Groundwater & Wastewater Services
Septic Project File & Data Review Worksheet

GWS File #: 6791B WASPS App #: 1414

IMPROVEMENT PERMIT for a RESIDENTIAL ON-SITE WASTEWATER TREATMENT & DISPOSAL SYSTEM

RE: Request for an Improvement Permit for Lot 53 off of Sample Road.
MCHD File #6791B

Scale: 1 inch equals 50 feet	S&ME	Faison - Sample Road LLC	FIGURE
Drawn by: JBP		Lot 53	1
Reviewed by: TCJ		Mecklenburg County, NC	
Date: June, 2007	ENVIRONMENTAL SERVICES • ENGINEERING • TESTING	S&ME Project #1588-05-091

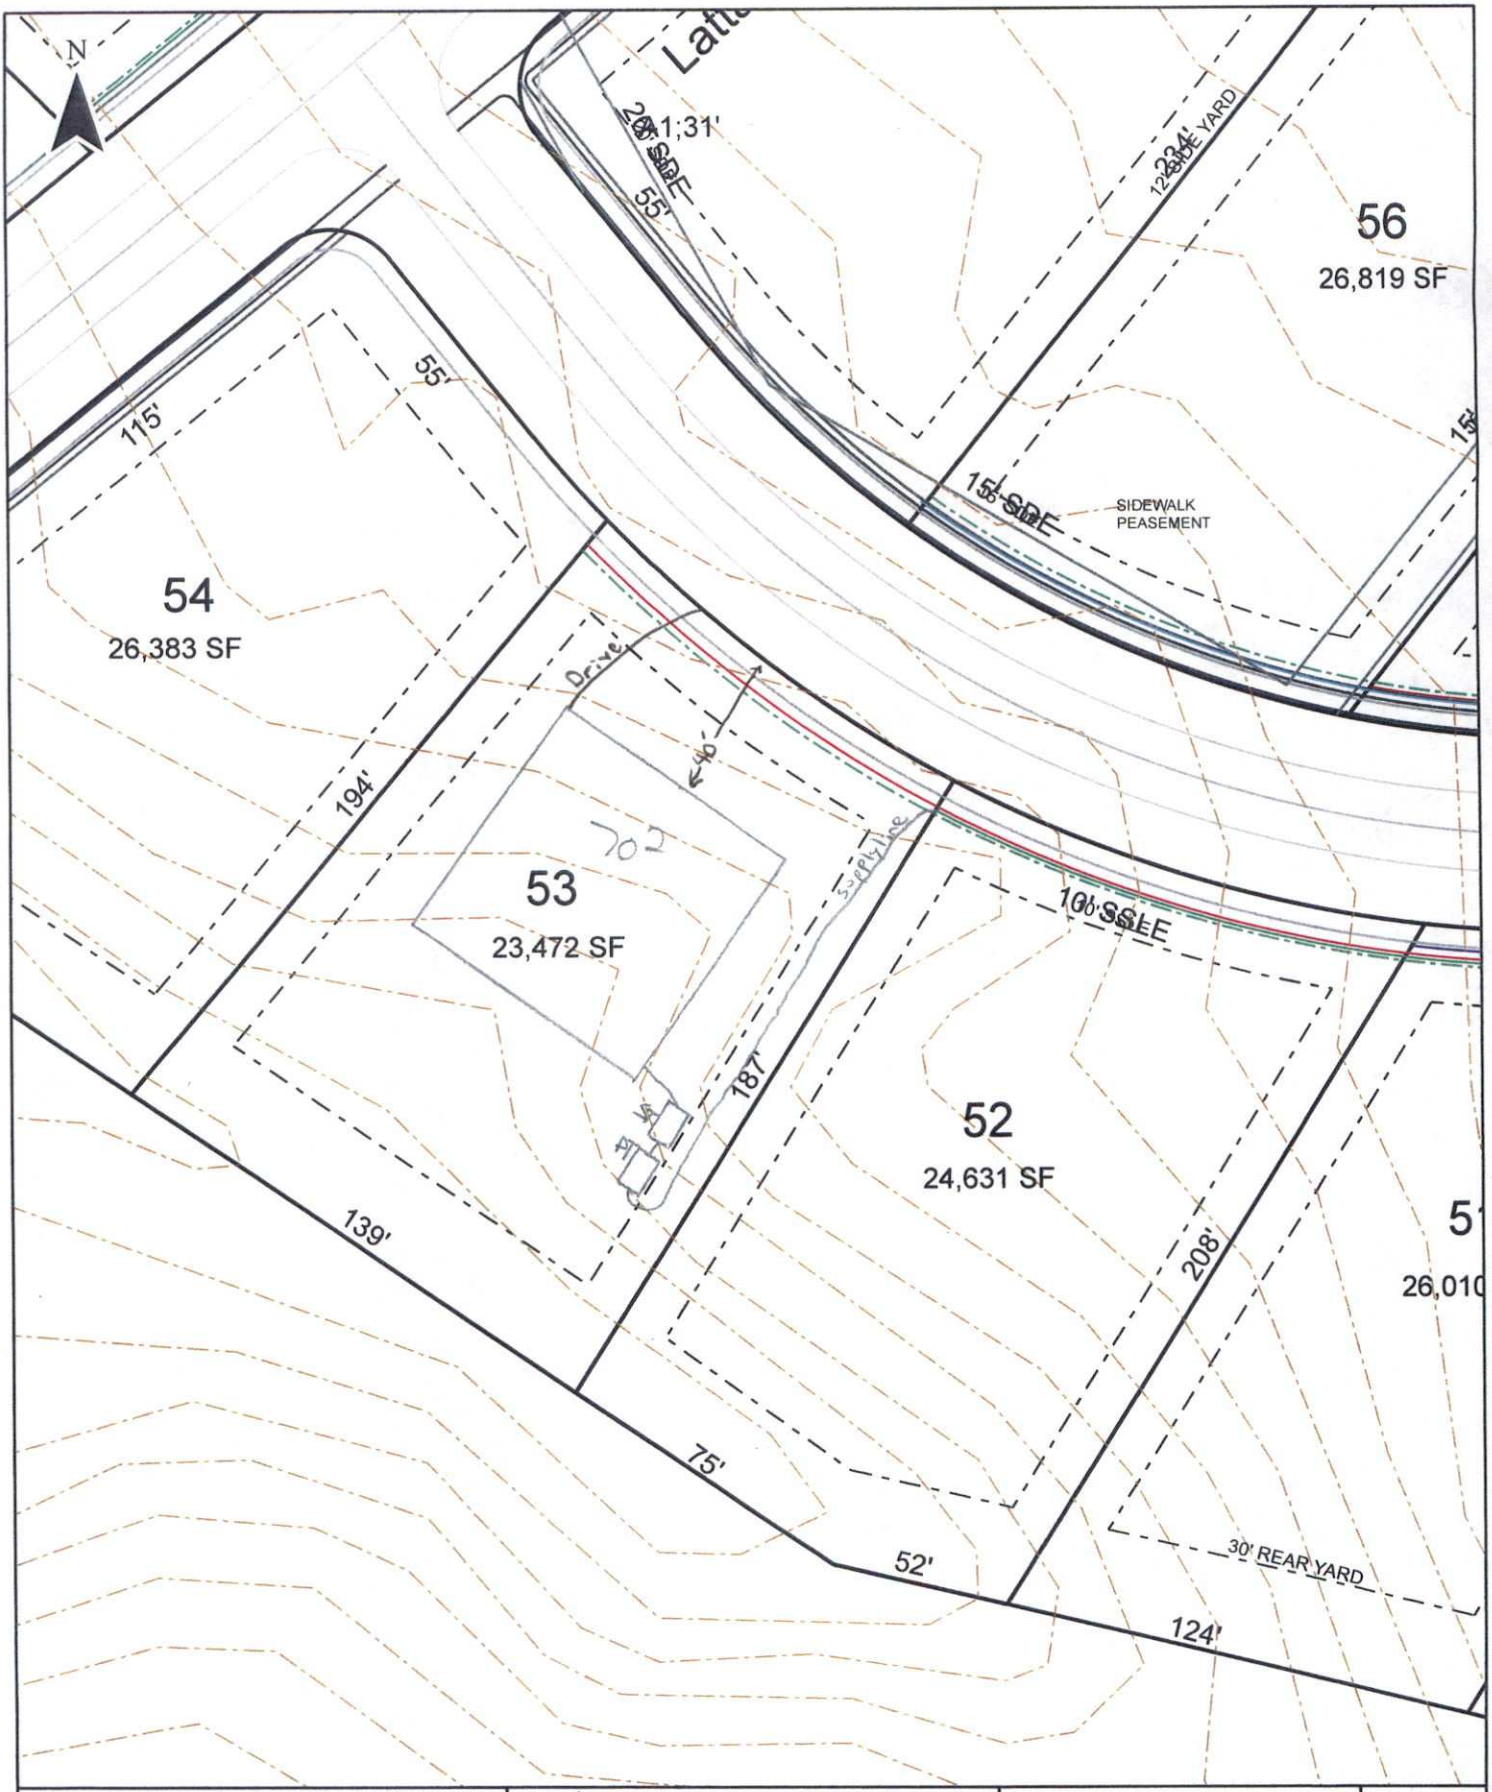
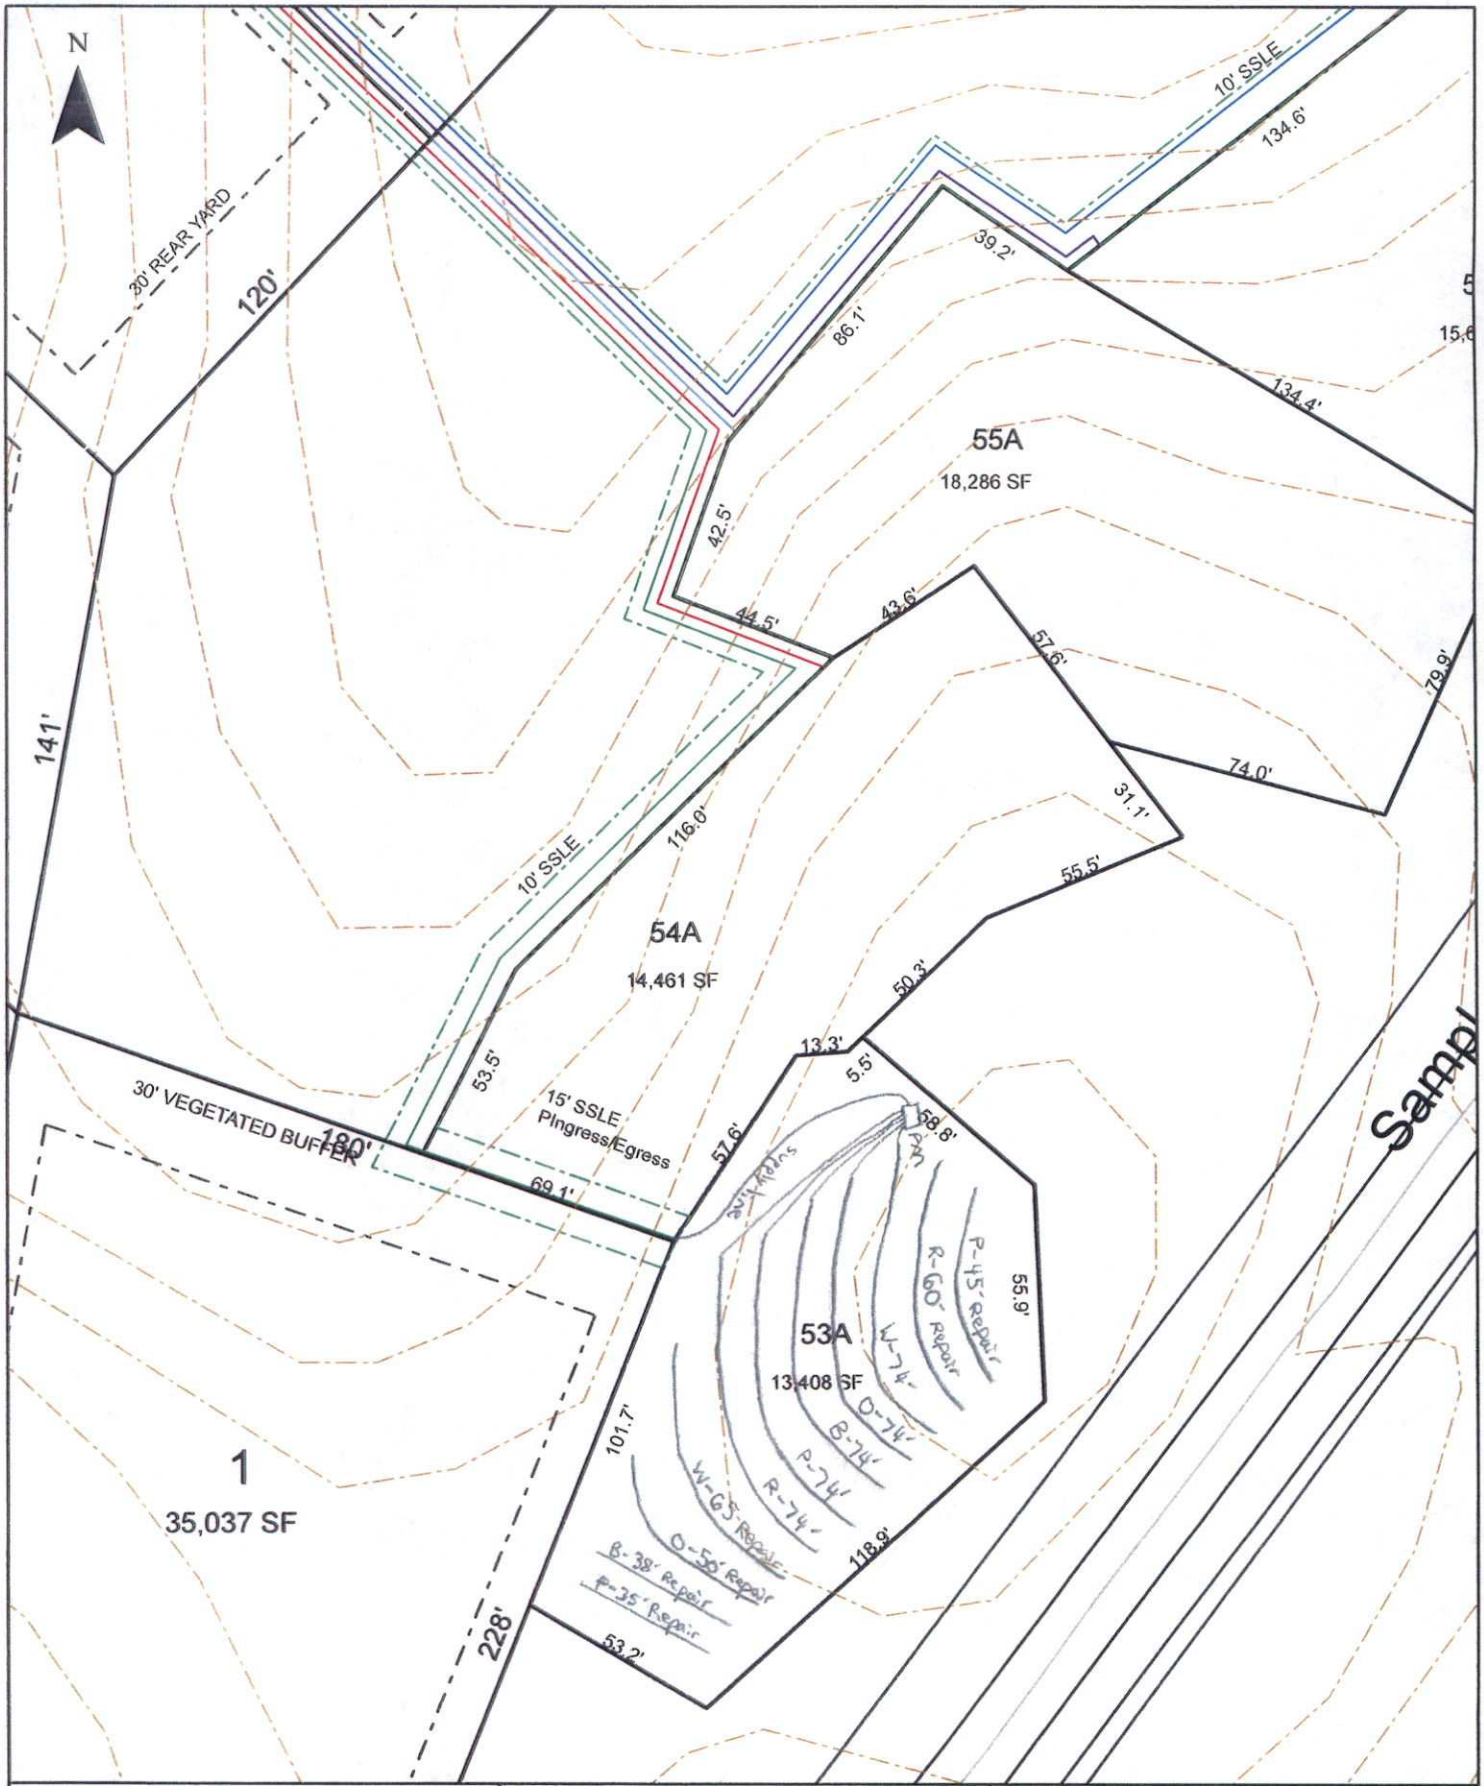
→ well needs to be properly abandoned on easement area.

- Proper well abandonment is required prior to receiving an Installation Approval from our office to install the septic system.
- The septic system shall be installed in accordance with the plans submitted by the wastewater system design consultant.

ENCASEMENT PIPE DETAIL

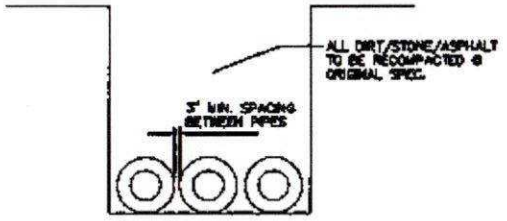
Mr. Fox-
Retreat at Latta specifically. I know NCDOT is much more reasonable, so I was wondering if we could do something a little less than welded steel pipe that may actually last longer. Welded Steel piping painted is $150K more than ductile iron with slip joints and tracer wires, and I cannot imagine there is a structural difference to the roadway. I would really like some help with that if you can.

Mr. Fox-
I was wondering if there is an alternate to the standard crossing detail or if we could propose an alternate to the welded steel pipe required by Huntersville. This is an extremely expensive option, and we would like to propose using ductile iron pipe with slip joints and different color tracer wires. We would still as-built everything the same, but the cost savings is tremendous, and the different color tracer wires would last longer than paint. Can you approve or is there someone else I'd need to go through?
Thanks,
Tom

Upon your request, you may use slip joint ductile iron encasement pipe in lieu of the welded steel pipe as indicated on the Encasement Detail for the low pressure sewer crossings at the Retreat at Latta. This change is being made due to the fact that ductile iron will provide adequate strength for the crossing as well as provide water tight seals at the joints. Please note however, this is the only change being made to that detail. Specified lengths, depths, and sizes shall still be in compliance with the detail.
